**Request for Additional Information No. 345**

**U. S. EPR Standard Design Certification**

**Docket No. 52-020**

**SRP Section: 09.02.01 - Station Service Water System**

Figure 9.2.1-1—Essential Service Water System Piping & Instrumentation Diagram  
Sheet 1 of 4

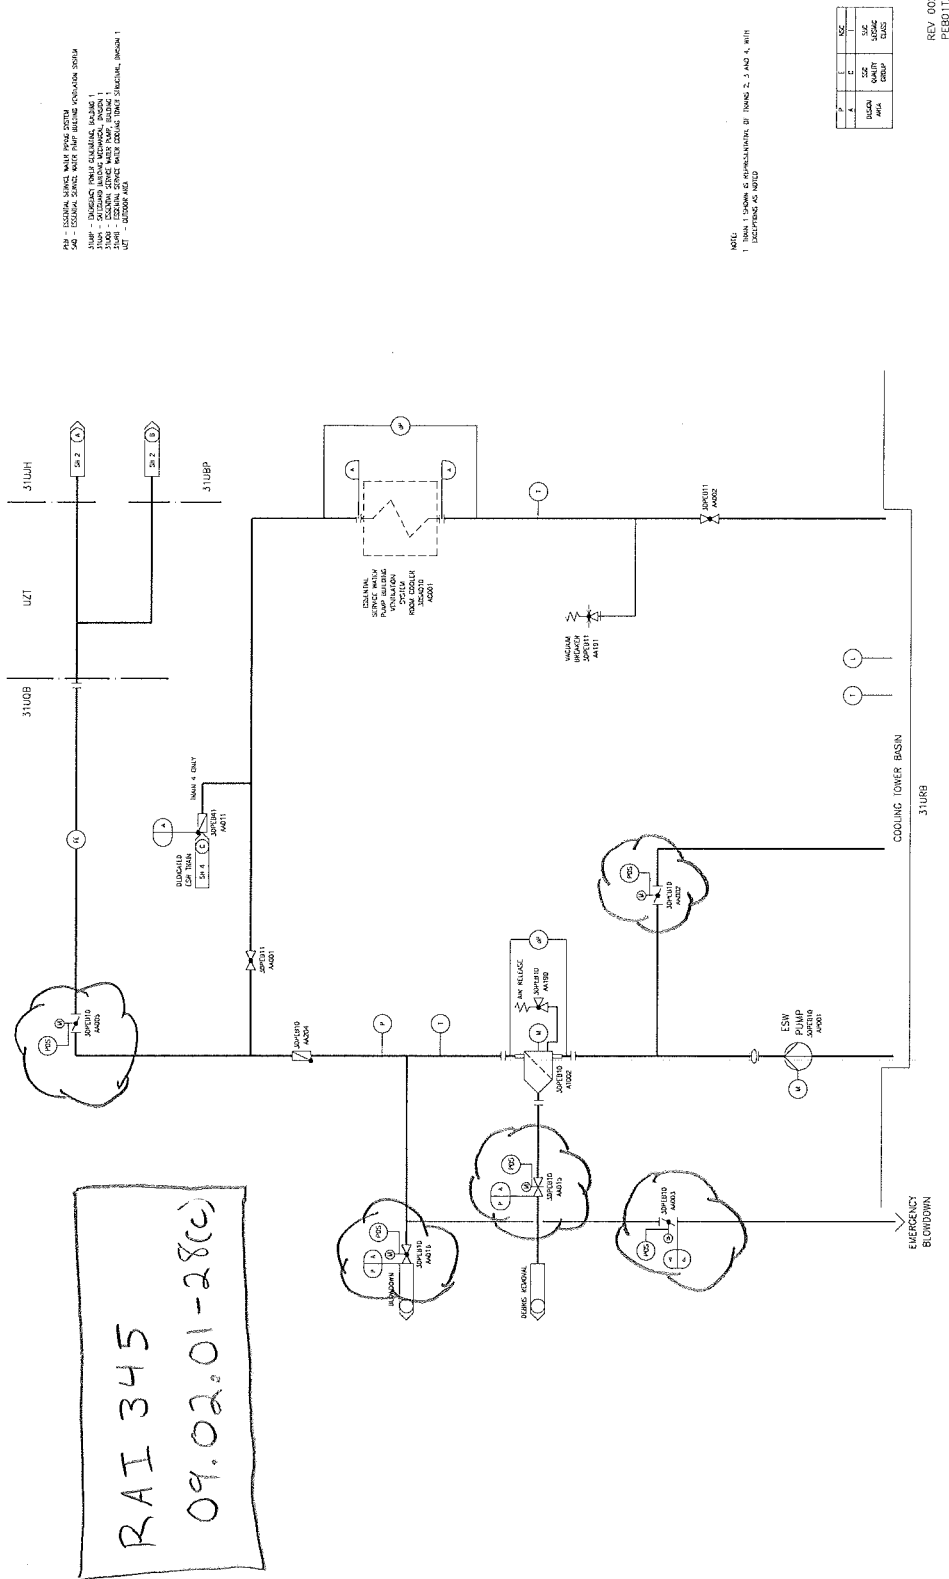
U.S. EPR FSAR Table 9.2.1-3 Alarm Summary will be revised to indicate which alarms will be provided in the MCR/RSS. The associated instruments provide input to a process computer and/or have alarm and automatic actuation functions. U.S. EPR FSAR Figure 9.2.1-1 will be revised to show which valves are monitored for valve position. U.S. EPR FSAR Section 9.2.1.7.1 will be revised to include valve position status and pump operating status as a monitored parameter.

U.S. EPR FSAR Tier 2, Section 9.2.1, Table 9.2.1-3 and Figure 9.2.1-1 will be revised as described in the response and indicated on the enclosed markup.

Figure 9.2.1-1—Essential Service Water System Piping & Instrumentation Diagram  
Sheet 4 of 4

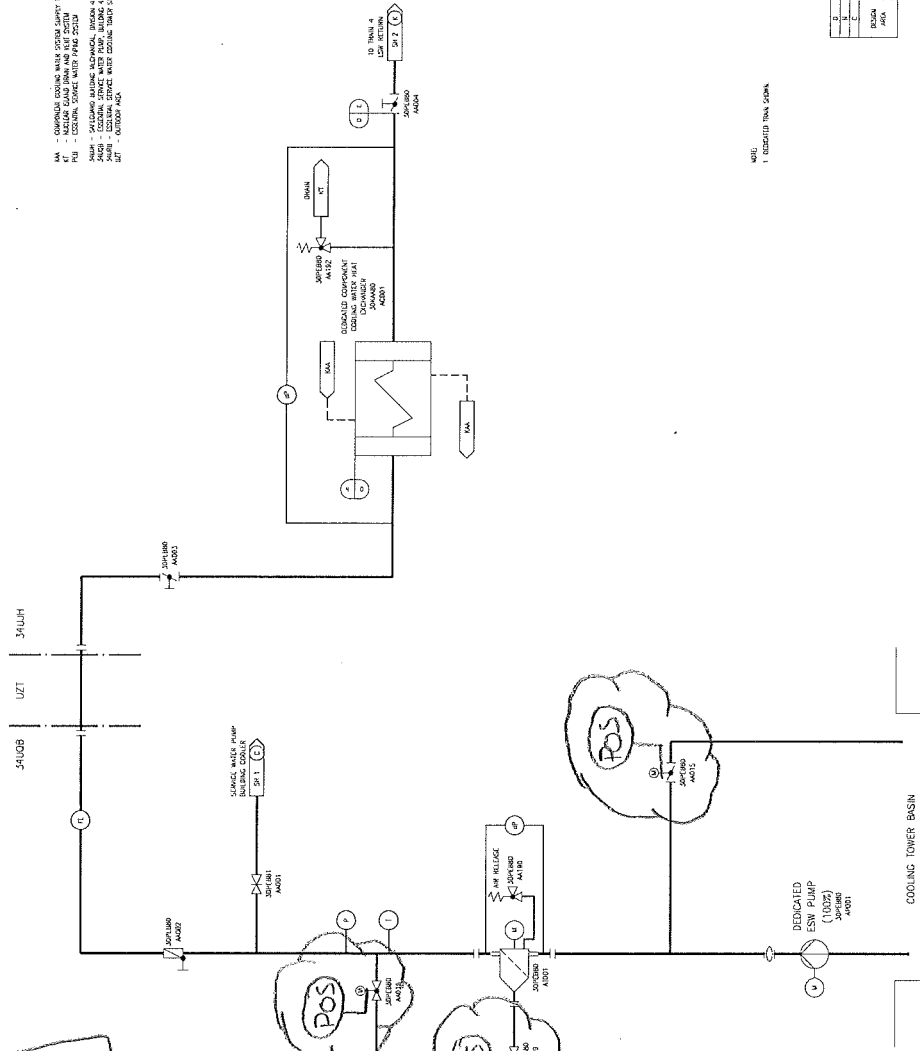
The applicant should identify the continuation of the dedicated blowdown line from Figure 9.2.1-1, Sheet 4 of 4.
